Access Compliance Report

Public Rights-of-Way

(Curb Ramps)

Intersection ID: 14978	Main Street: COLONNADE_DR	Cross Street: MONROE_RD	Location: NE
ADA ID: E56C73049C2B	Ramp Type: PerpDiag	Initial Pass/Fail: Fail	Overall Compliance: No
			Severity Score: 58.75

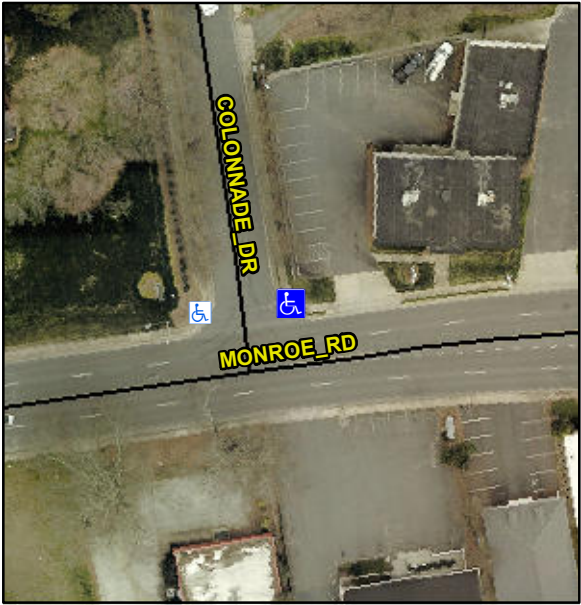
Codes/Mitigation Info/Possible Solution			Field Measurements/Component Compliance		
	Possible Solutions:		Compliance	Description	Data
	Remove & Replace Curb Ramp With Two New Directional Ramps or Equivalent.		No	Ramp Length (in)	70.0
			No	Ramp Width (in)	36.0
			N/A	Flare Type LT	N/A
			N/A	Flare Slope LT (%)	N/A
			N/A	Flare Traversable LT?	N/A
			N/A	Landing Length (in)	N/A
			N/A	Landing Width (in)	N/A
			N/A	Landing Slope (%)	N/A
			N/A	Landing X Slope (%)	N/A
<p>Surveyor Notes:</p> <p>N/A</p> <p>PROW/ADA:</p> <p>Not Found, R304.5.1, R304.2.2, R304.5.3</p>			N/A	Flare Type RT	N/A
			N/A	Flare Slope RT (%)	N/A
			N/A	Flare Traversable RT?	N/A
			N/A	DWS Provided?	N/A
			N/A	DWS Contrast?	N/A
			N/A	DWS Length (in)	N/A
			N/A	DWS Full Width?	N/A
			N/A	DWS Offset (in)	N/A
			N/A	Gutter Ponding?	N/A
			N/A	Gutter Lip Ht (in)	N/A
			No	Painted X Walk1?	No
			To W	X Walk 1 Direction	To S
			N/A	X Walk 1 Width (in)	N/A

1.4	X Walk 1 Slope (%)	14.1
			13.2	X Walk 1 X Slope (%)	5.2
			N/A	Ramp inside XWalk1?	N/A
			12.1	Road Slope (%)	N/A
			5.0	Road X Slope (%)	N/A
			N/A	Any Obstructions?	N/A
			N/A	Obstruction Type	N/A
Total Cost: \$ 3200.00			N/A	Storm Grate/Utility Hazard?	N/A
			N/A	Storm Grate/Utility Type	N/A
			Yes	Surface Condition? (G/P)	Good
